ADDENDUM NO. 01

Baggage Screening Improvements – Phase 2A
[Loading Dock Reconfiguration, Sheriff’s Checkpoint Removal, Jetway Installation
(Gate 30, 46, 47), IAB Airside Trash Remodel, North Checkpoint Relocation]

PROJECT NO. A044-09002

DATE OF ADDENDUM: June 9, 2011

C300A

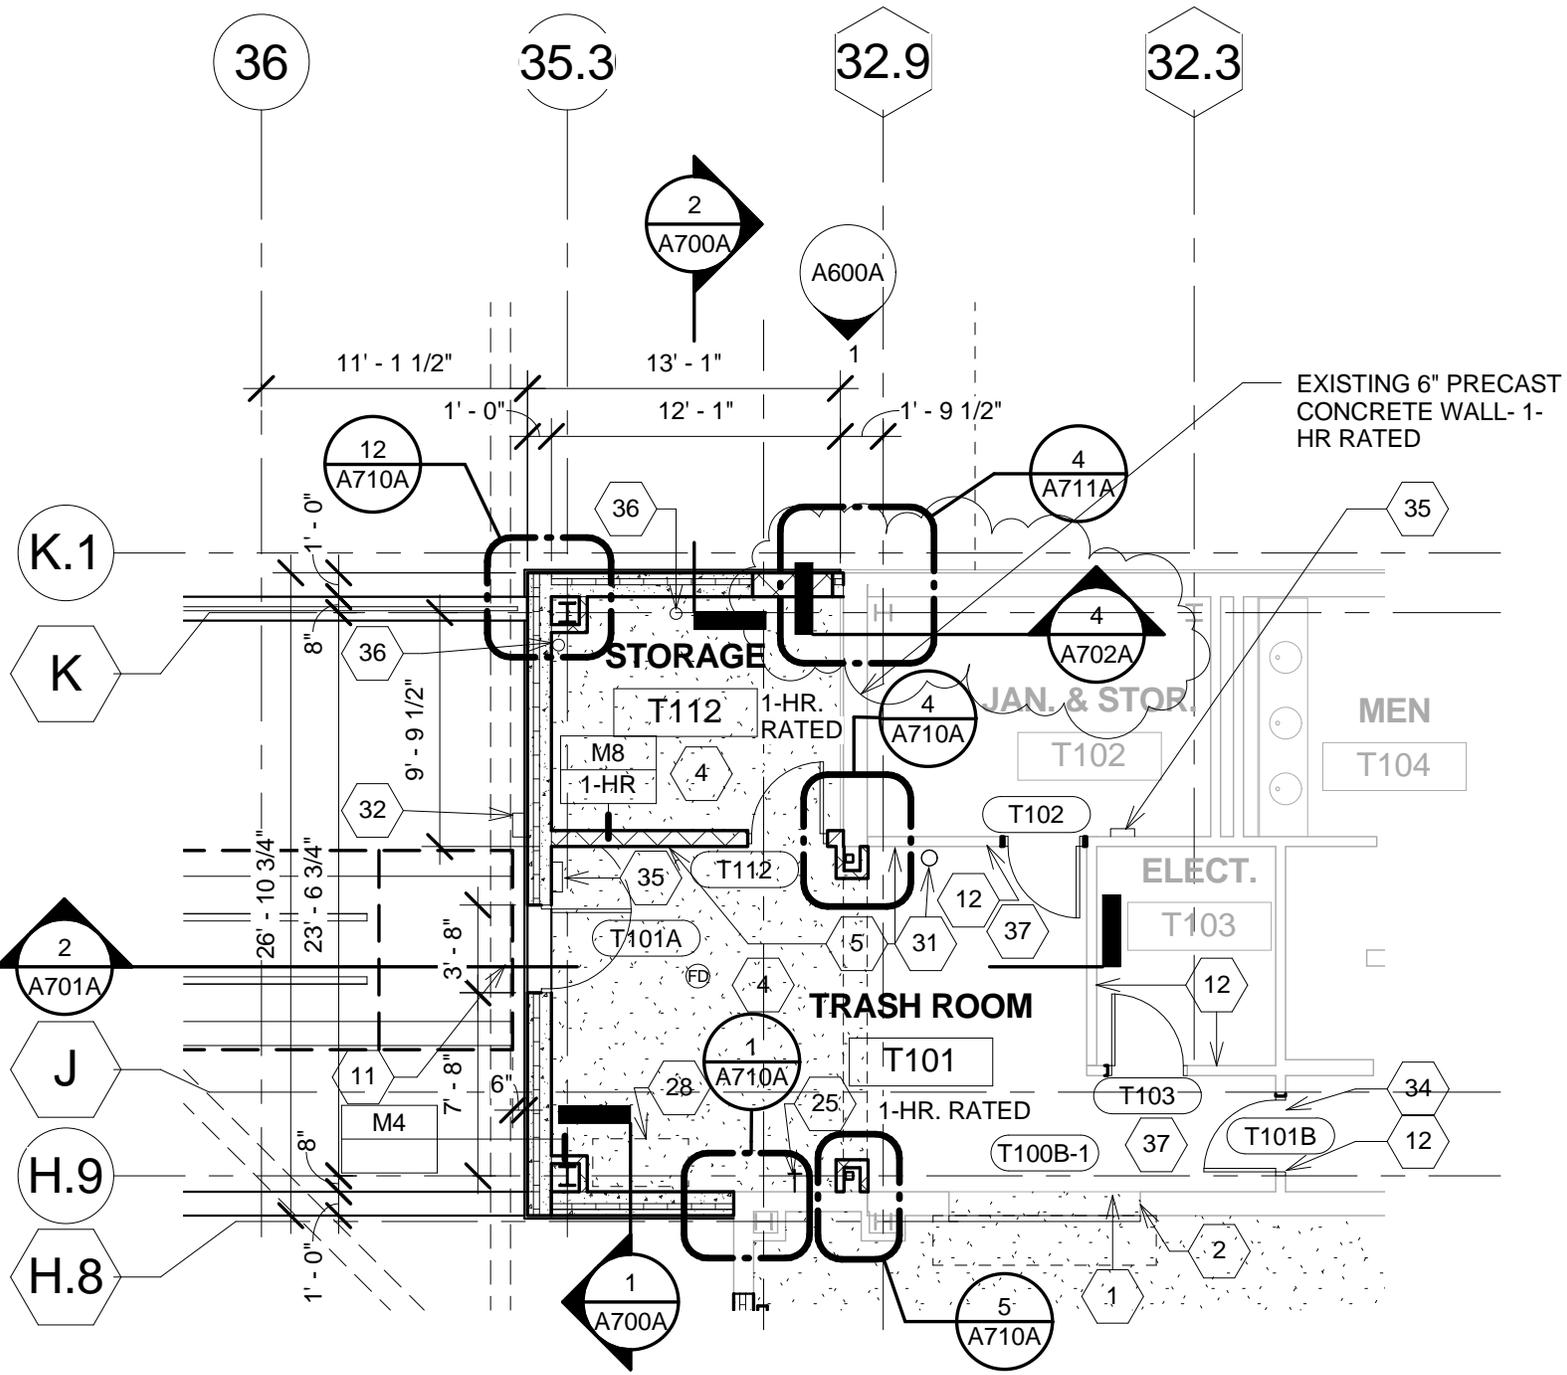
Erosion Control Note #12 provided on Sheet C203A has been changed to prescribe a maximum of 14 days before stabilization is required as opposed to 30 days. (see attached drawings)

A702A

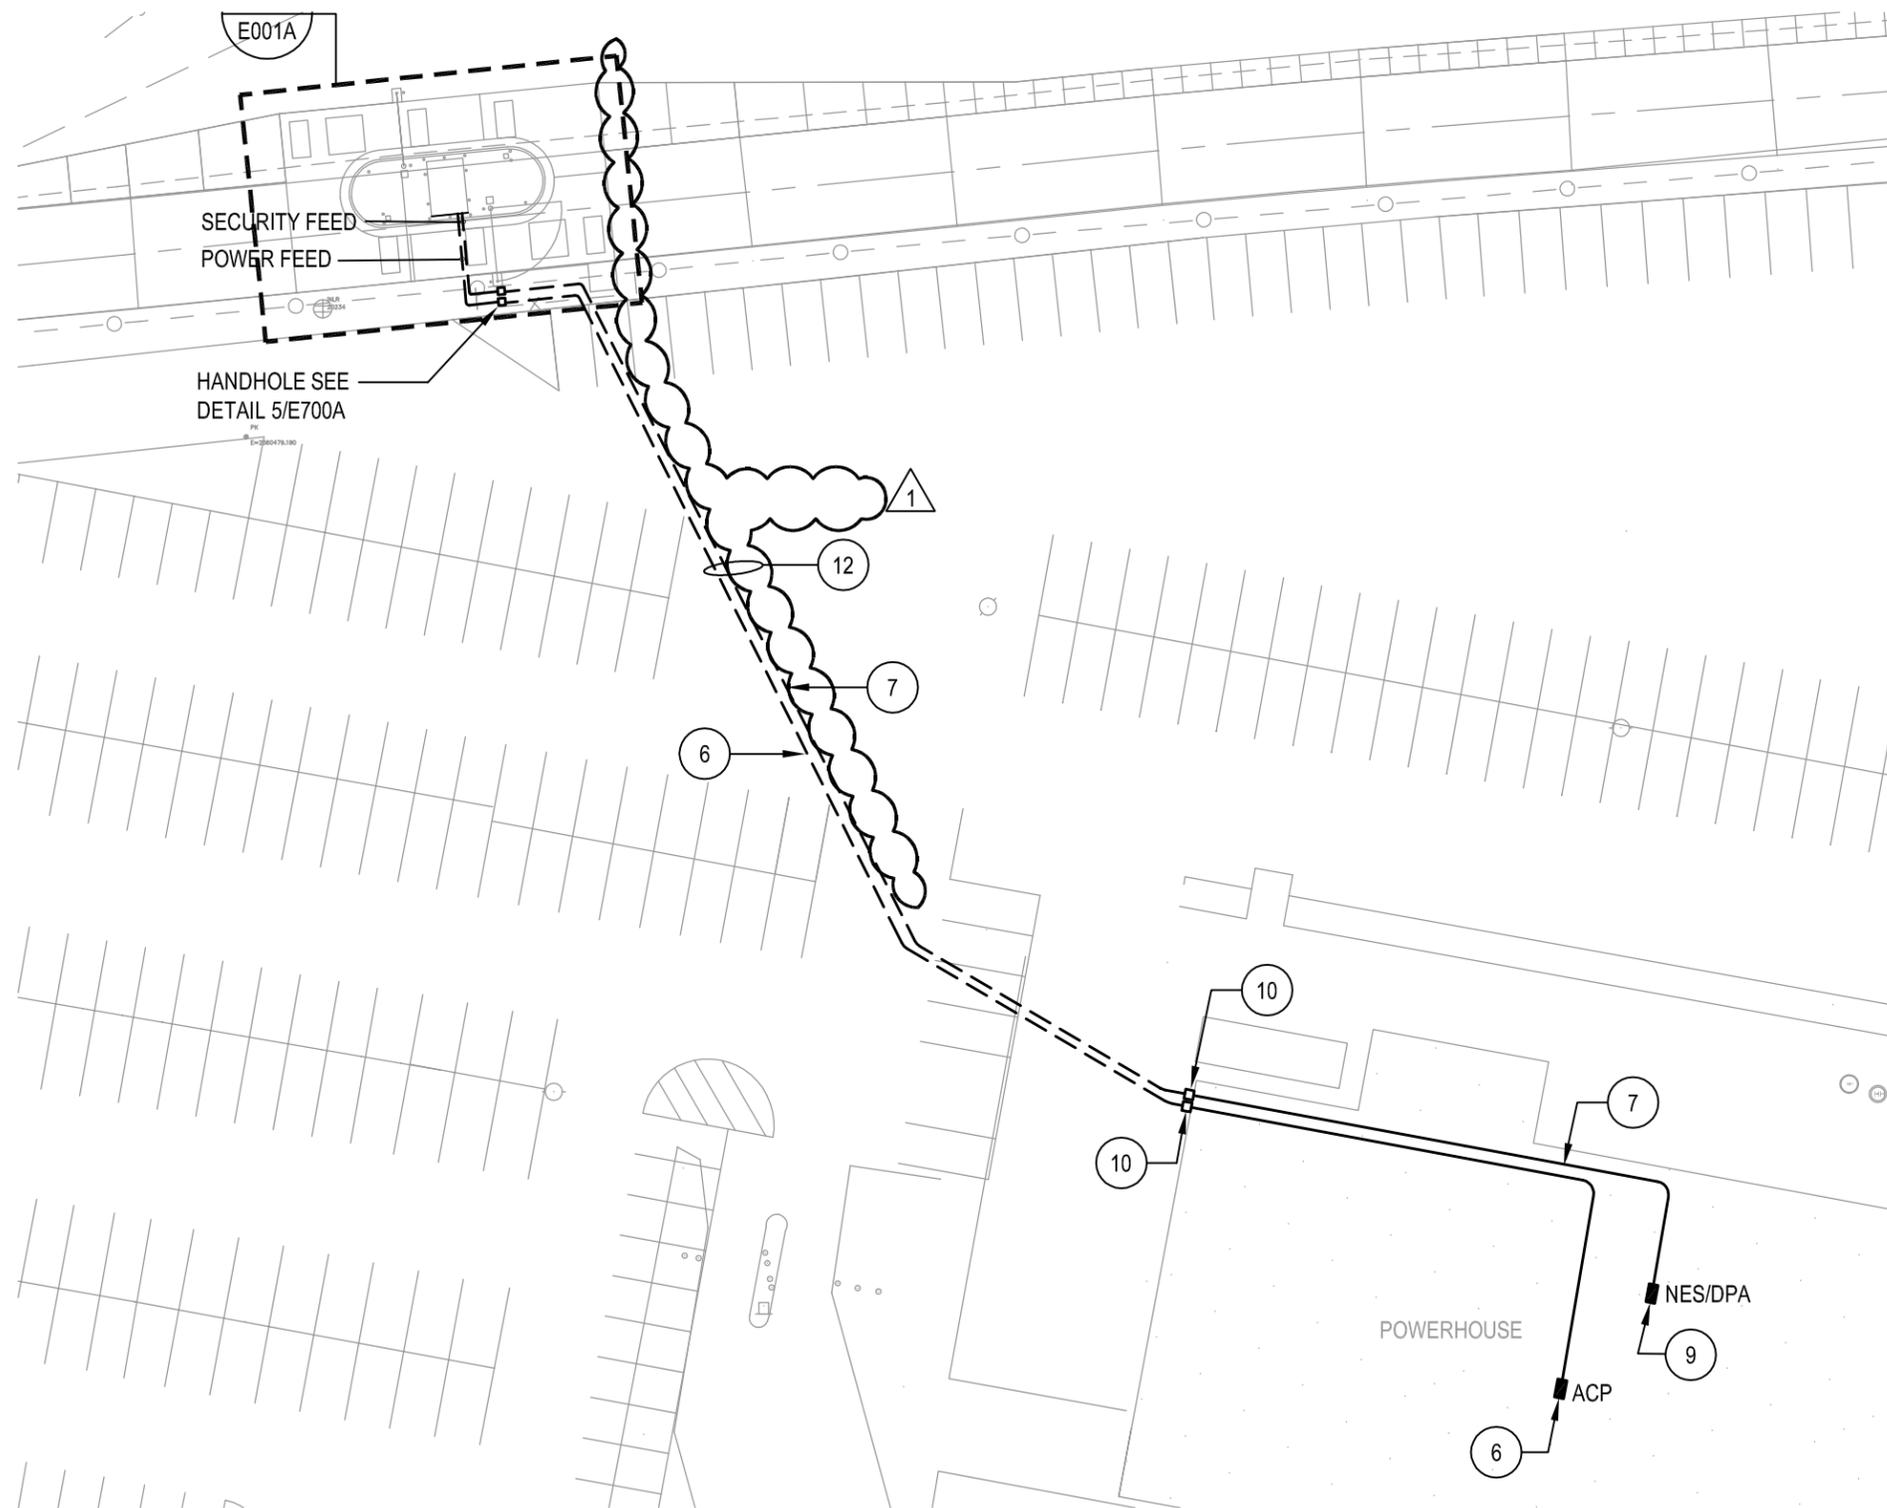
- ADD new **Detail 4** Section at Precast Wall Infill. See attached drawing. (see attached drawing A101A and detail 4/a702A)

E001A

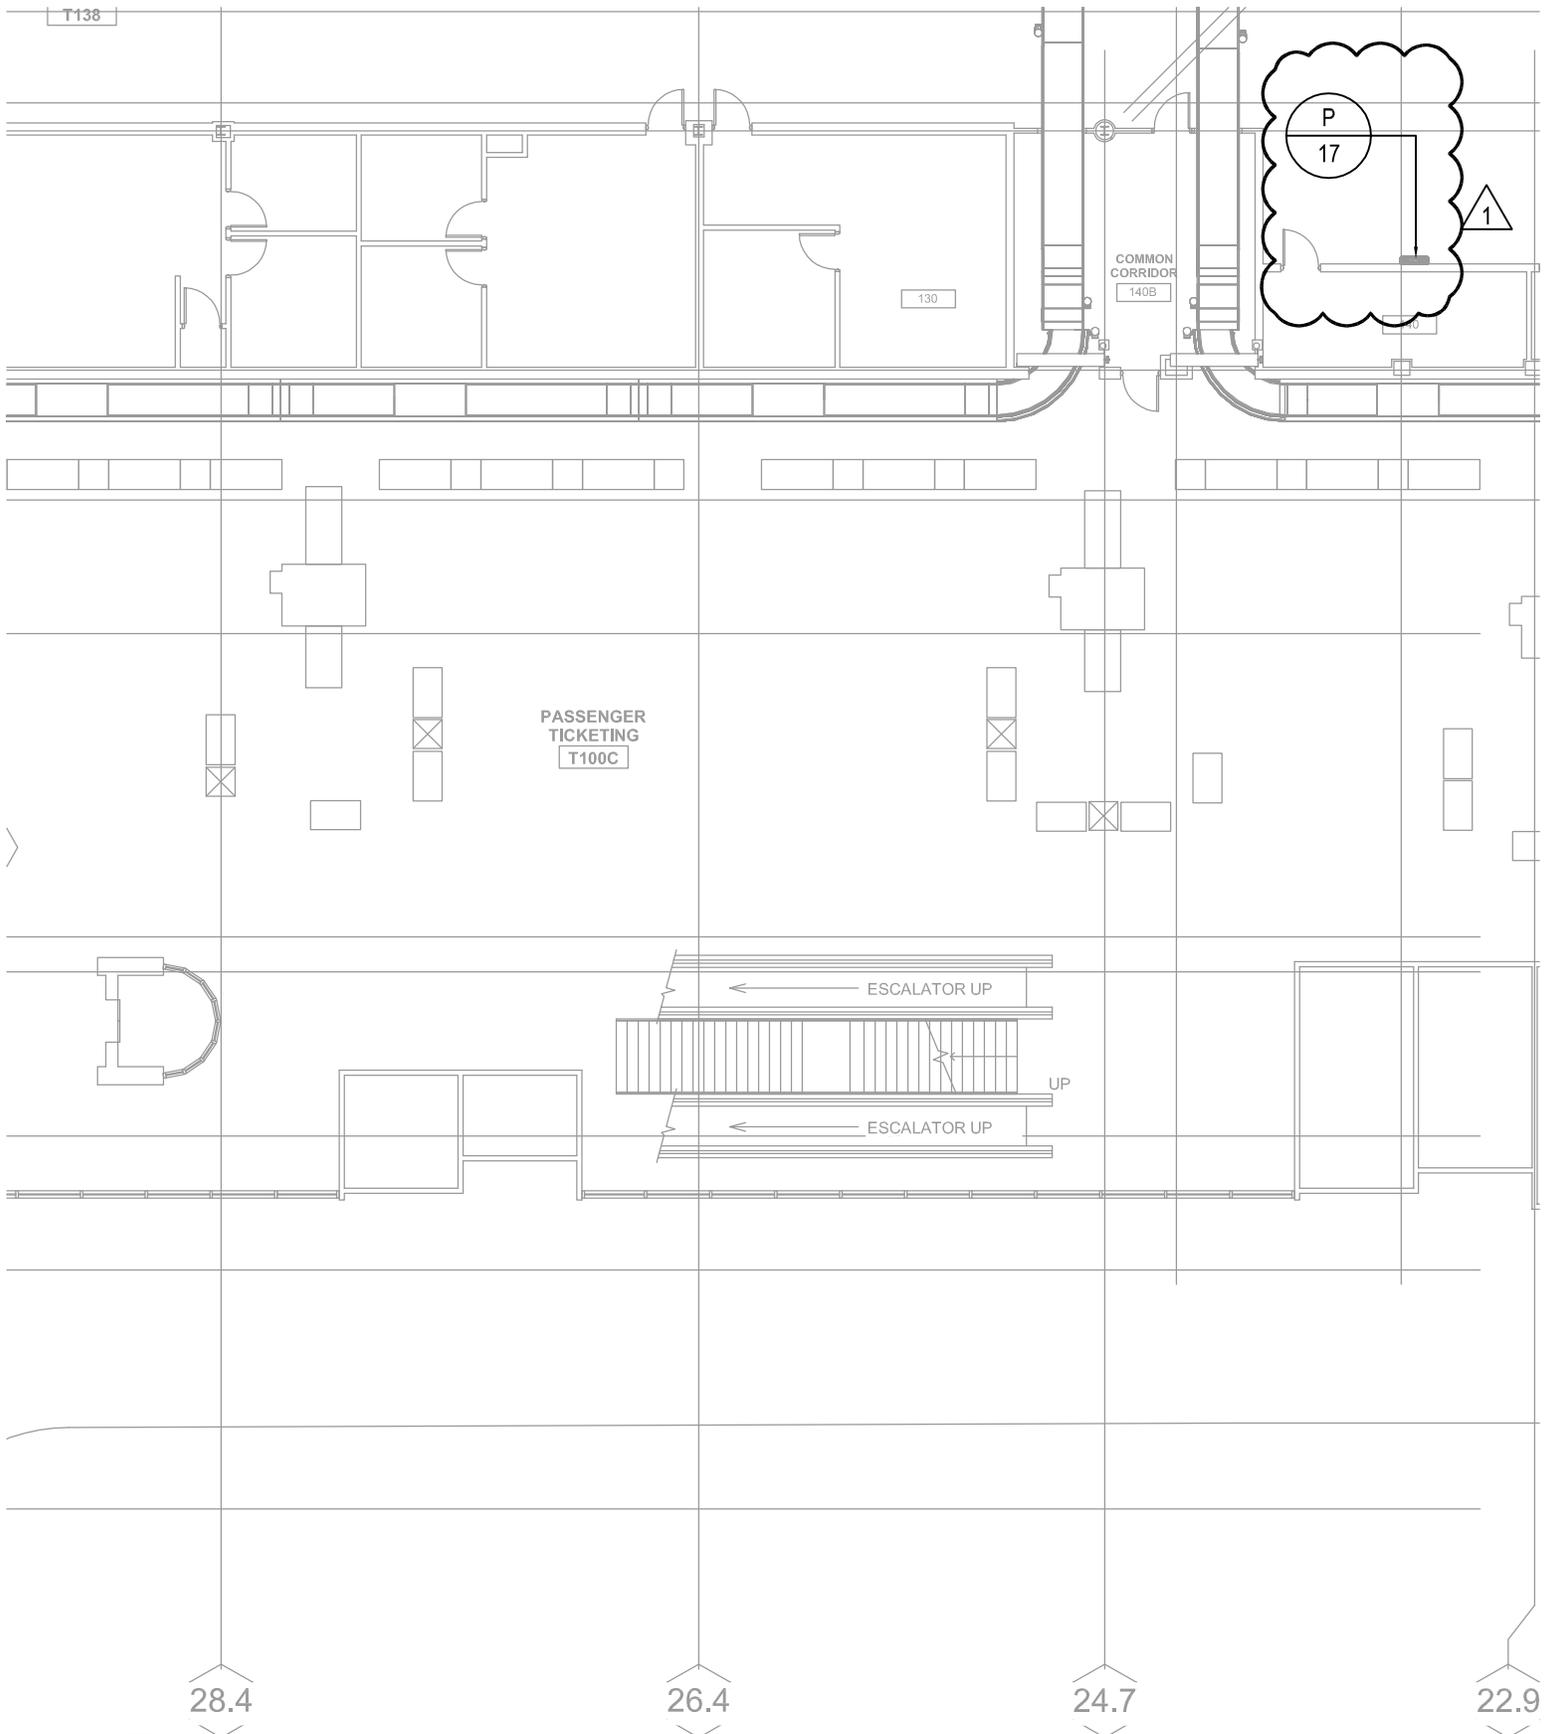
- Deleted concrete ductbank as shown on attached sketch.
- Deleted reference to Note 13 on plan. Changed Note 13 to read “Not Used.”
- Changed Note 6 from “12 strand fiber optic cable” to “12 strand single mode fiber optic cable”
- Changed Note 7 from “with (2) #1, (1) #1 GND” to “with (2) #6, (1) #6 GND”.

- ⑥ PROVIDE 2" CONDUIT WITH 12 STRAND SINGLE MODE FIBER OPTIC CABLE FROM GATE CONTROL PANEL TO ACP ON FIRST FLOOR OF POWER HOUSE.
- ⑦ PROVIDE 2" CONDUIT WITH (2) #6, (1) #6 GROUND FROM PANEL NES/DPA IN POWER HOUSE TO TRANSFORMER AT GUARD HOUSE. SEE DETAIL 2/E600A.
- ⑬ NOT USED.

E101A

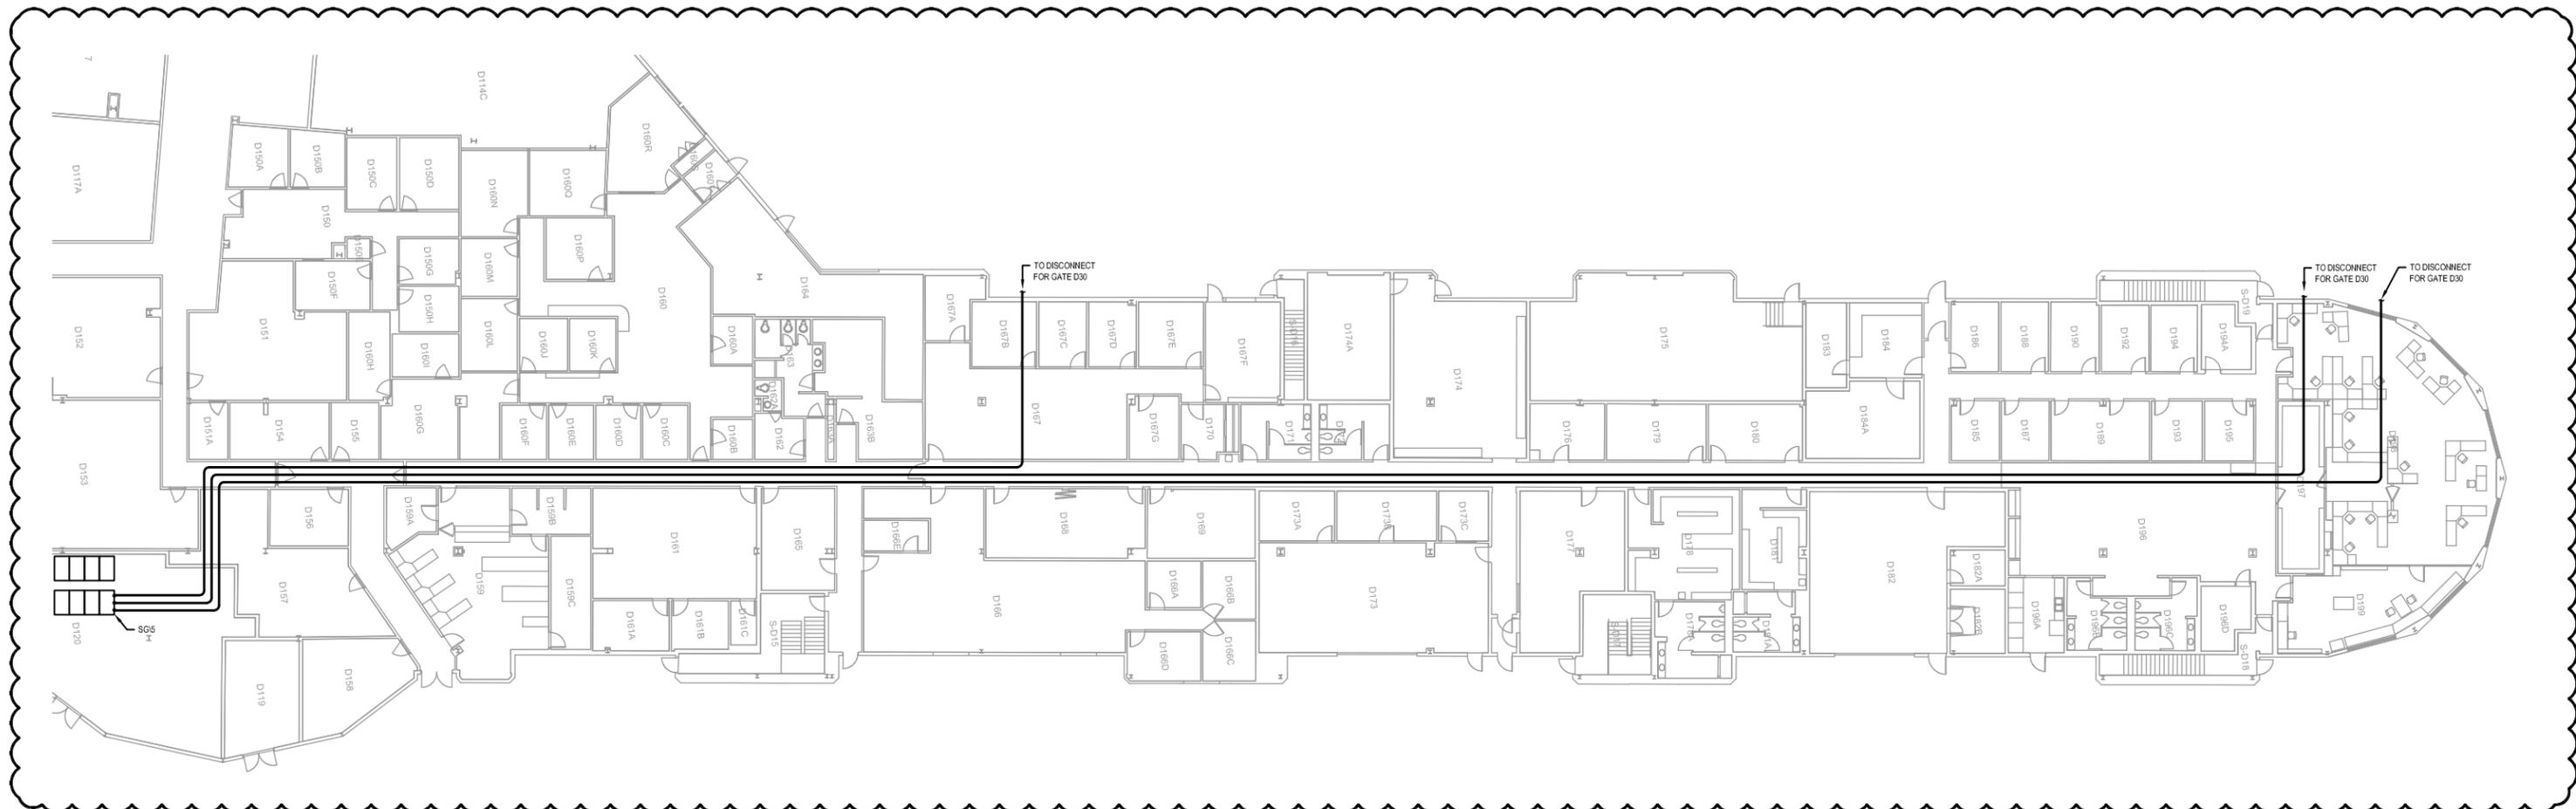
- Added detail to show the location for panel P17.

- 4) Drwg E101A: Please indicate location and manufacturer of existing panel P/16. **Response: This was changed from Panel P/16 to Panel P/17. The location for this panel P/17 is included in the addendum.**

E104A

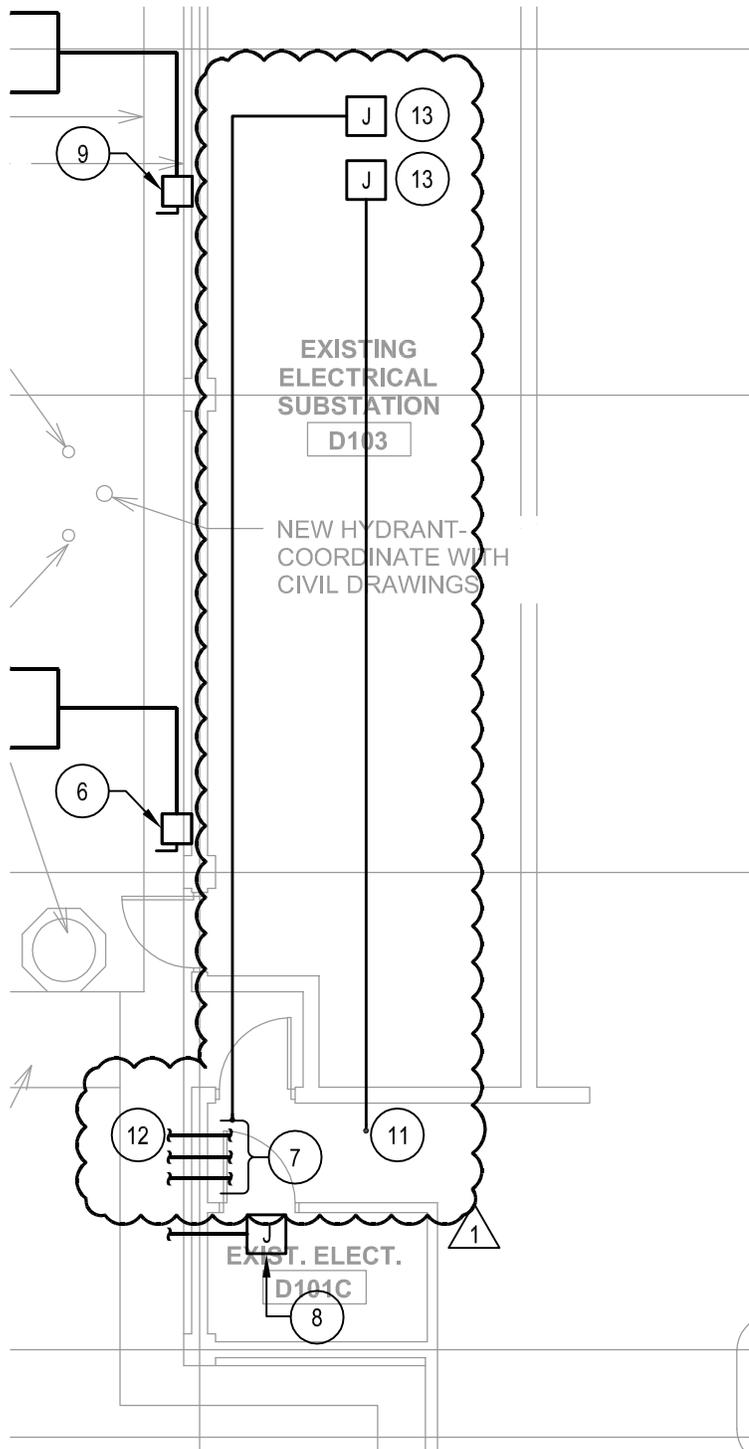
- Added detail to shows the approximate feeder routing and the location for Switchgear 5/6.

- 5) Drwgs E103A and E105A: New jet bridges are fed from existing switchgear SG/5 in room D120 per one-line diagram. Where is SG/5, room D120 indicated on drawings? What is the routing of the three 400A feeders to room D120? Please indicate location of SG/5 and feeder routing on drawings so we can scale the lengths of the feeders. **Response: The location for this switchgear and feeder routing is included in the addendum.**
